**Subject: Northland Power Long Lake Solar L.P. - Proposed Modification to the
Long Lake Solar Project Layout
(MOE Ref No. 6351-8ZDSGP)**

H334844-0000-90-218-0212, Rev. 0

PROJECT No.
**LONG LAKE SOLAR PROJECT
LONG LAKE PROPERTY - SITE PLAN**

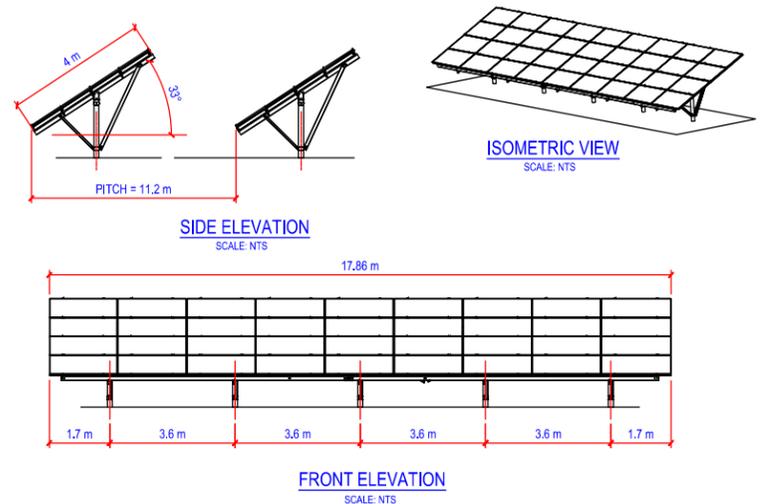
The first proposed change is to alter the location of the transformer substation by moving the substation 65 m south. Coordinates for both the original proposed location of the transformer, as well as the revised location of the transformer, are provided below:

- Original Location: 17 U 479683.51m E, 5443619.44m N
- Revised Location: 17 U 479683.51m E, 5443554.44m N

The second proposed change is that Northland will obtain a quieter transformer substation in order to further reduce the noise from this equipment (details are provided within the Noise Assessment Study Report to be provided separately).

As a result of the above, there will be a greater than 50% reduction in encroachment of noise greater than 40 dBA on vacant lots north of Concession 8&9 adjacent to the Project location. No additional mitigation measures or environmental effects monitoring are therefore required. Based on the reduced off-site noise levels, the proposed changes are determined to be a Technical Amendment.

There are no changes to the text of the Executive Summary, Construction Plan Report, Design and Operations Report, Natural Heritage Environmental Impact Study, or the Water Body Environmental Impact Study, however the layouts/site plans previously provided within these reports are replaced with the new Project layout provided in Attachment A of this letter.
